DESIGN DEVELOPMENT
ADAMSTOWN BOULEVARD
PHASE 1

MCCAULEY DAYE O'CONNELL ARCHITECTS

AUGUST 2022

THE FOLLOWING ARE EXAMPLES OF AMENDMENTS THAT HAVE BEEN MADE AS A
RESULT OF DESIGN DEVELOPMENT POST-PLANNING SUBMISSION.

H2AB/AC/AD

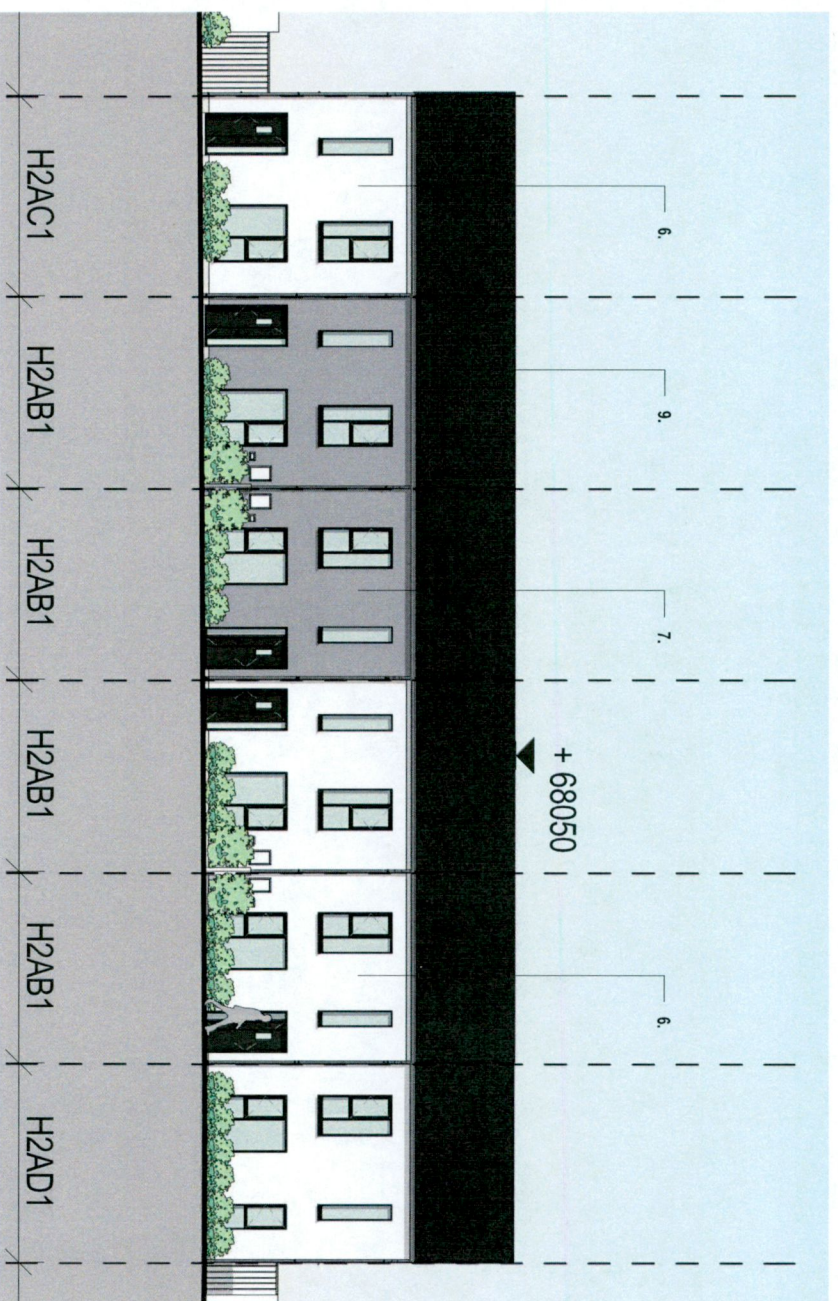
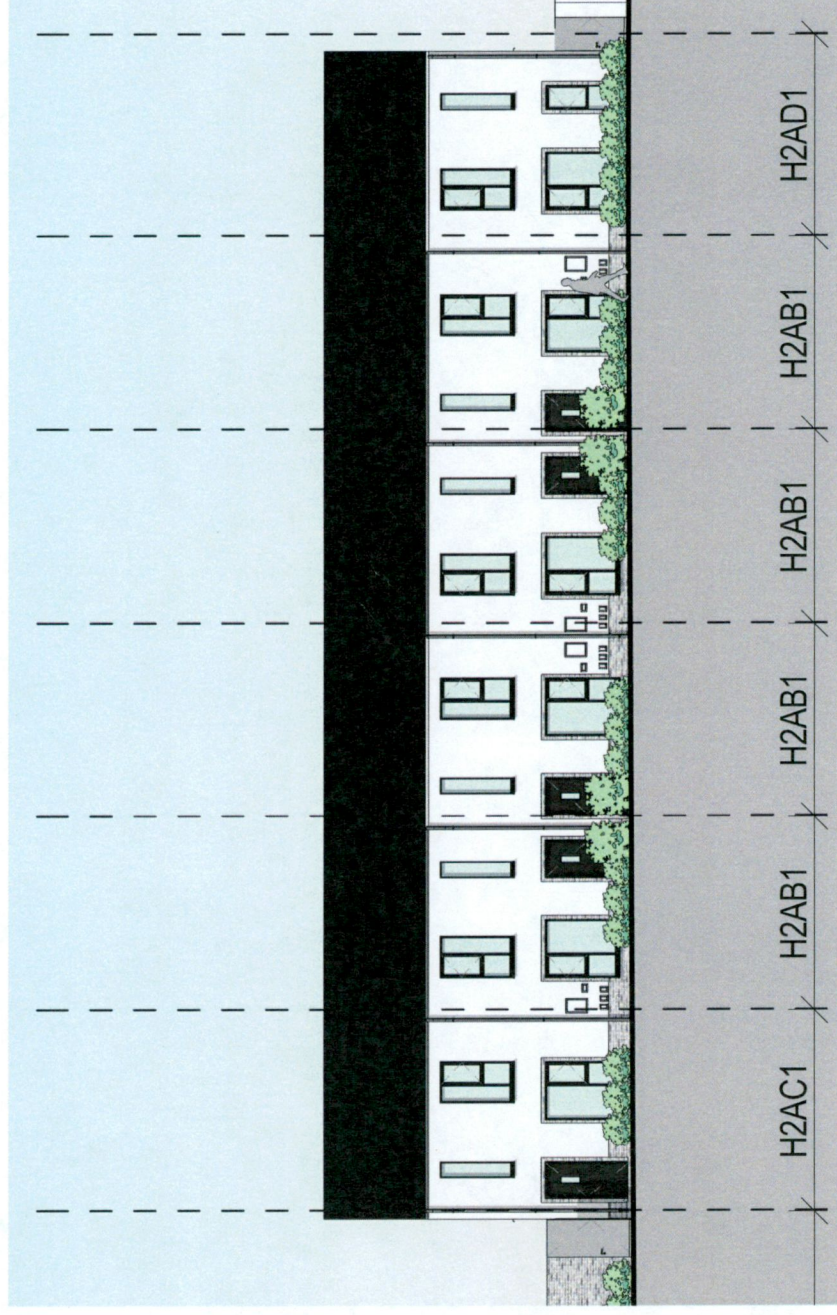
1. Brick introduced to plinth and window/door surrounds to tie in with other house types on the tile.
2. Render colour amended.

H3BA

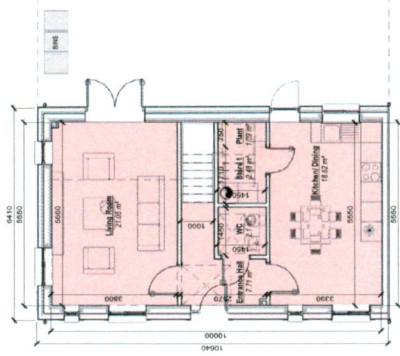
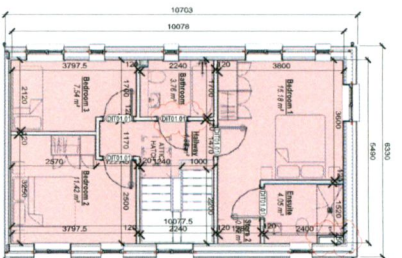
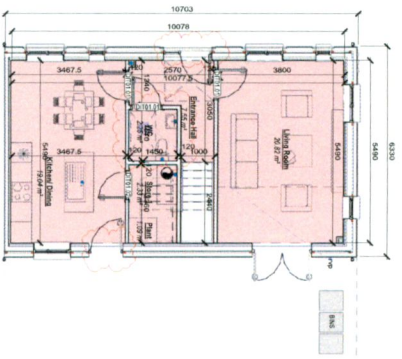
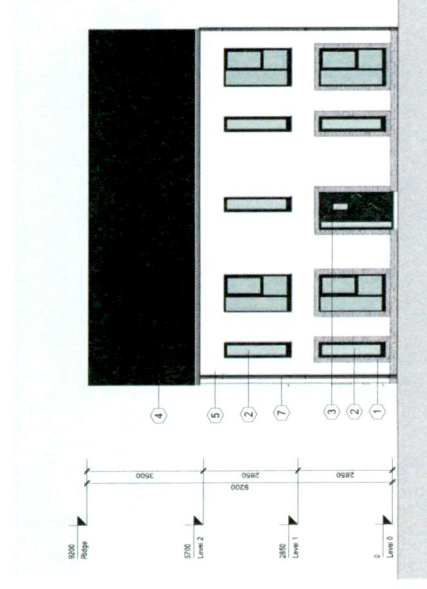
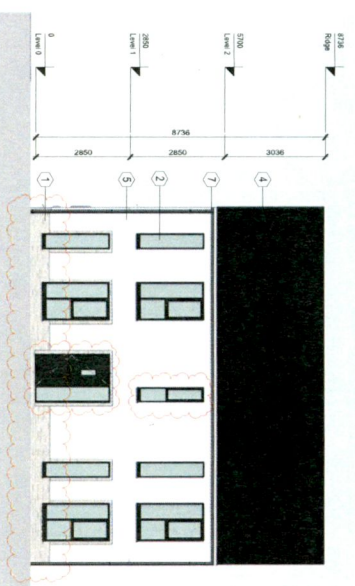
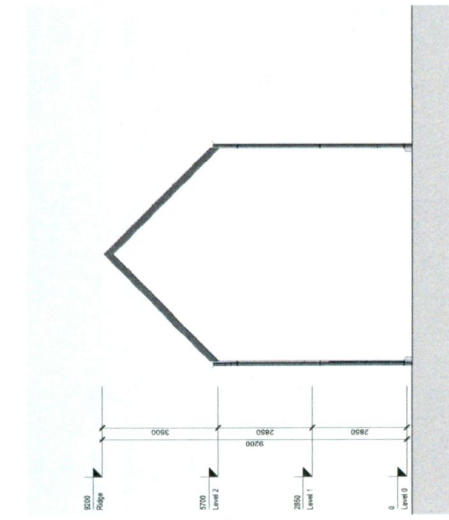
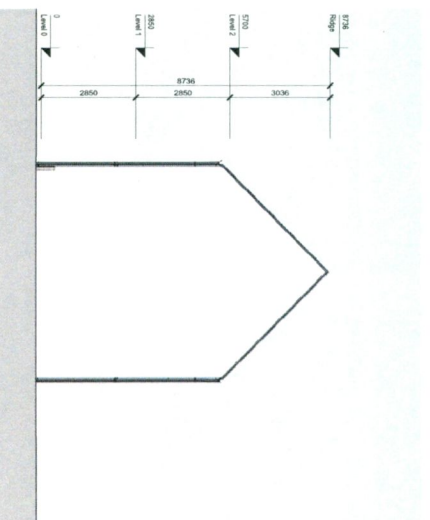
- Different brick colour on Front Elevation and brick pilinth height increase.
- Change of window types and entrance door type on Front Elevation.
- Internal layout changes. WC rearrangement on Level 00 and Bathroom door position on Level 01.

H3AC2

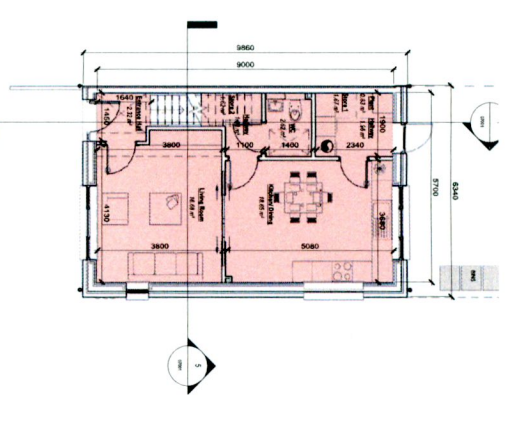
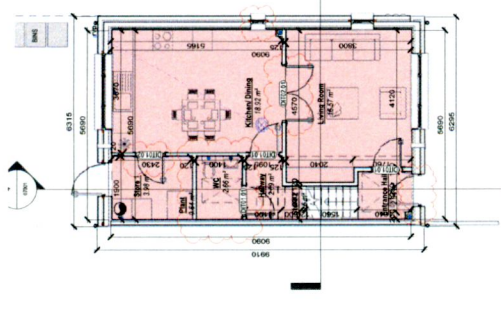
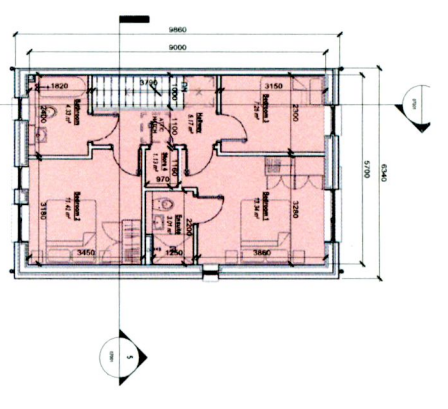
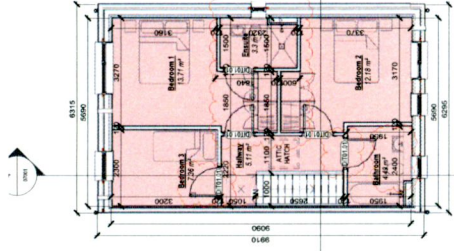
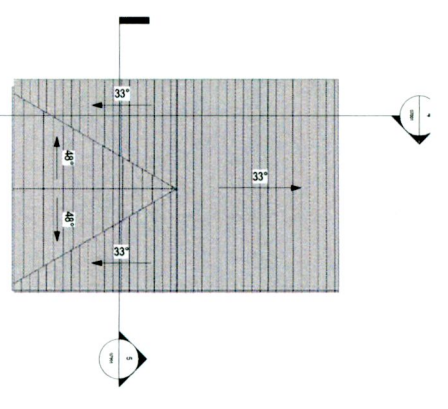
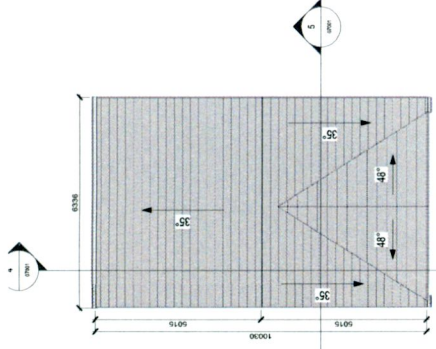
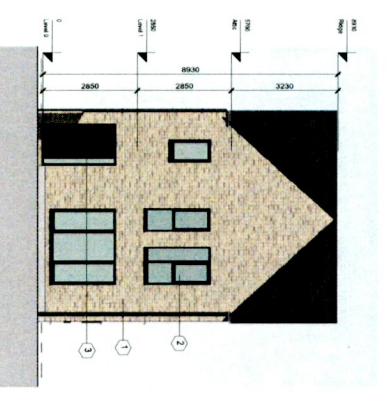
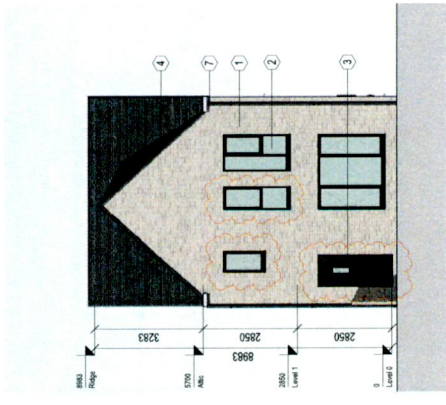
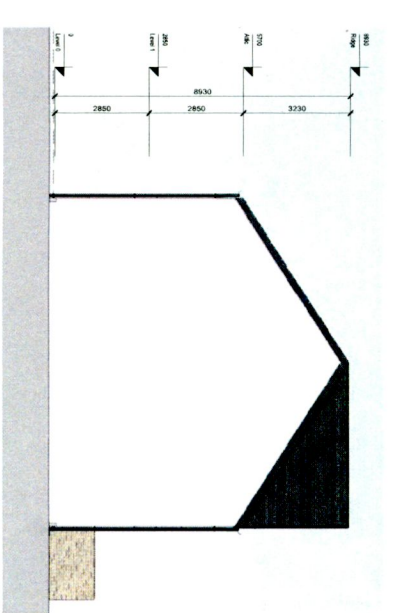
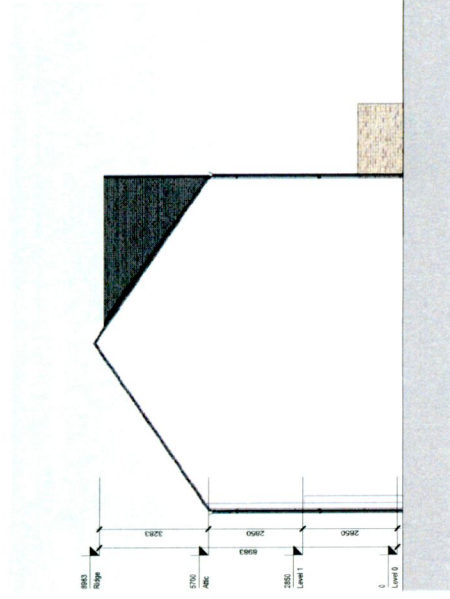
- Gable overlooking side passage modified, change of material from brick to render finish and windows rearrangement.
- Change of entrance door type on Front Elevation and opening direction of windows.
- Level 00 Internal layout changes. WC rearrangement. Living room sliding door replaced for double door. Doors position.
- Level 01 Internal layout changes. Toilet and storage rearrangement. Doors position and opening direction.
- Roof Level. Change of ridge level and slopes.

H4AD

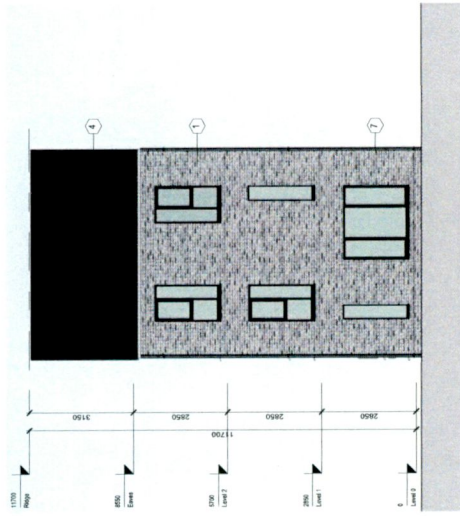
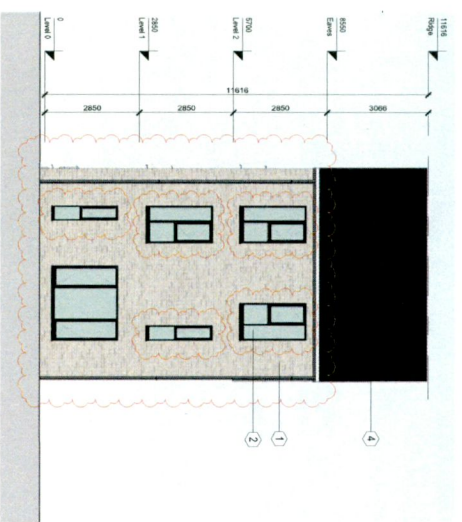
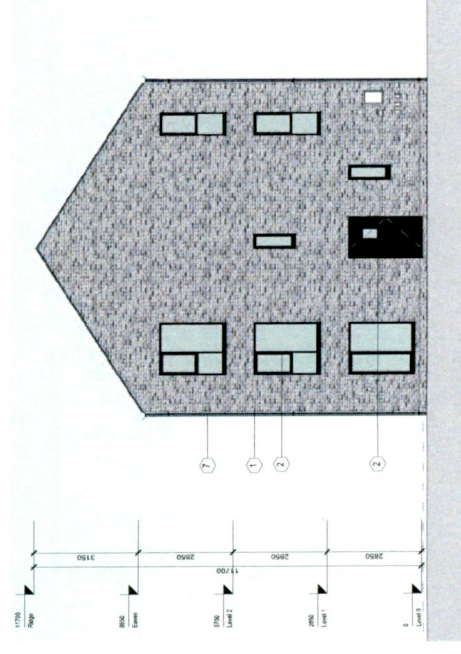
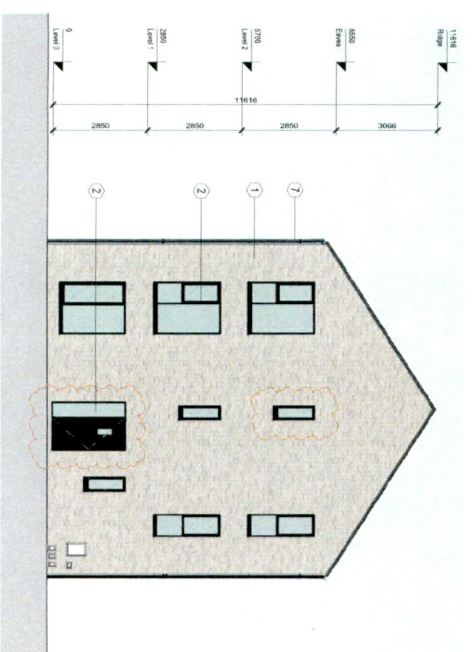
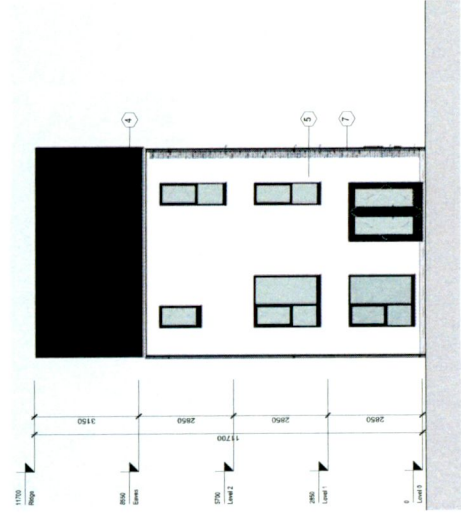
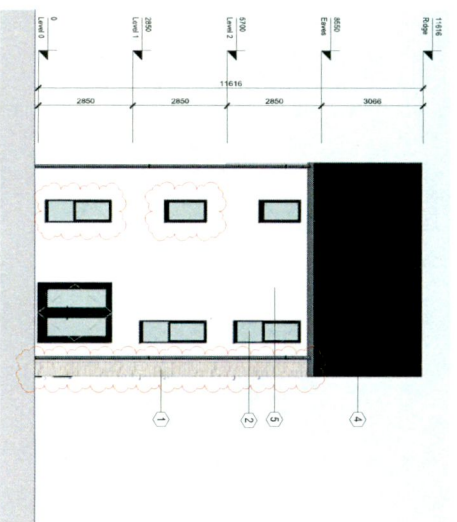
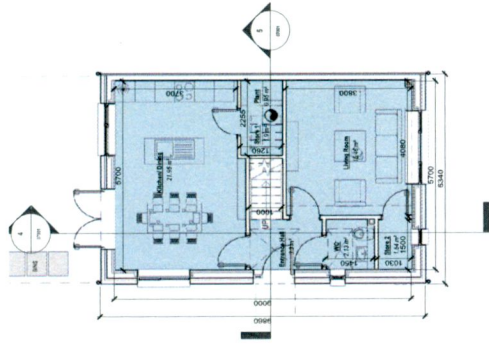
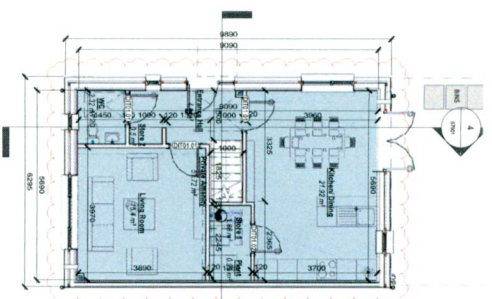
- *Design modifications proposed:**
- Different brick colour on Front and Side Elevation A proposed.
 - Change of window types and opening orientation.
 - Brick colour and window types change on Rear Elevation.
 - Entrance door type change and new window on Side Elevation A
 - Internal layout changes
